Model: Be-C2		Date: 14-Feb-19	No.: RD212012
Subject: FSM correction -Replacement of Developer and Toner-		Prepared by: A Shigeta	
From: 2nd Technical Support Sect., Service Strategy Dept			
Classification:	<input type="checkbox"/> Troubleshooting	<input type="checkbox"/> Part information	<input type="checkbox"/> Action required
	<input type="checkbox"/> Mechanical	<input type="checkbox"/> Electrical	<input checked="" type="checkbox"/> Service manual revision
	<input type="checkbox"/> Paper path	<input type="checkbox"/> Transmit/receive	<input type="checkbox"/> Retrofit information
	<input type="checkbox"/> Product Safety	<input type="checkbox"/> Other ()	<input type="checkbox"/> Tier 2

Please correct the descriptions in **red** to your FSM in the following section:

2. Installation -> Main machine -> Installation Procedure -> Developer and Toner

Developer and Toner

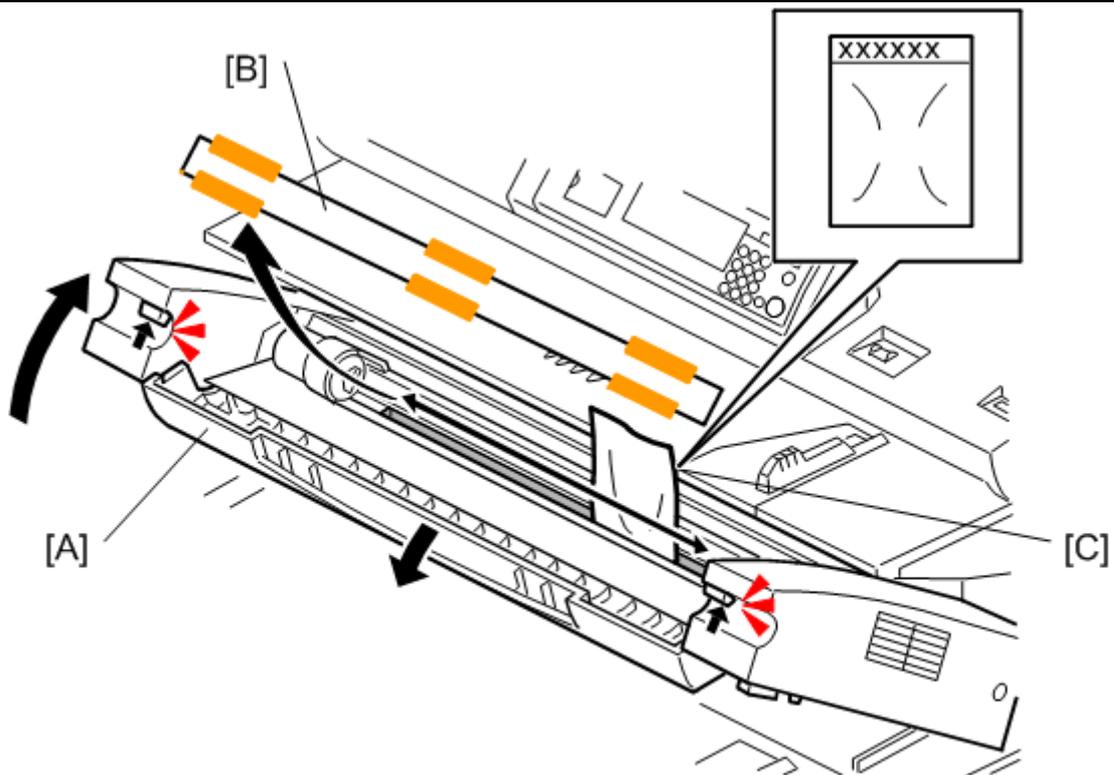
- ~~There are two 1-kg packs of toner provided. Do not open each pack until you are instructed to do so in the procedure below.~~
 - **Toner and developer are not included as accessories. Procure toner and developer for new site installs. 2 packs of developer will be necessary. (As a standard procedure, toner is procured as supply and developer as service part.)**
 - A developer lot number is embossed on the top edge of each package.
 - Keep these top edges after you open each developer package.
 - You will need these numbers when you input them later in **SP2801-2** and **-3**.
4. Open the first 1 kg pack of developer [C] and pour it into the development unit.
 - Slowly pour the developer into the development unit, as you move the pack from left to right until the pack is empty.
 - An equal amount of developer must be spread along the entire open slot of the development unit.

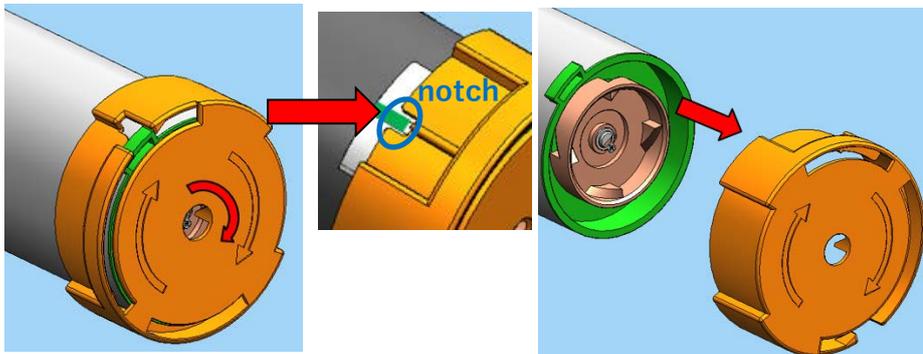
- **Show the customer how to prepare a toner cartridge for installation.**
- **A toner cartridge should never be put on its end or stored vertically.**
- **Do not remove the tape from new toner cartridge at this time.**
- **Rotate that knob in the direction marked on it until the green line appears in the notch area. Once the green line appears, pull the knob out.**

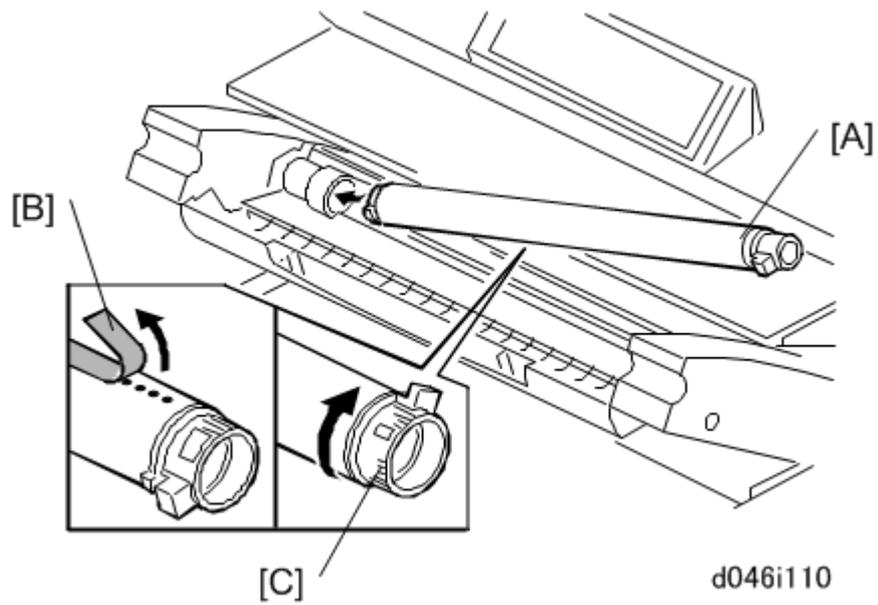
20*. Install the new toner cartridge[A]. (You can refer to the decal attached to the left side of the machine.)

- **Peel off the green tape [B] from right to left to expose the perforated clear tape (these are the toner supply holes). (This clear tape is not removed.)**
- **Rotate the knob [C] until it stops.**
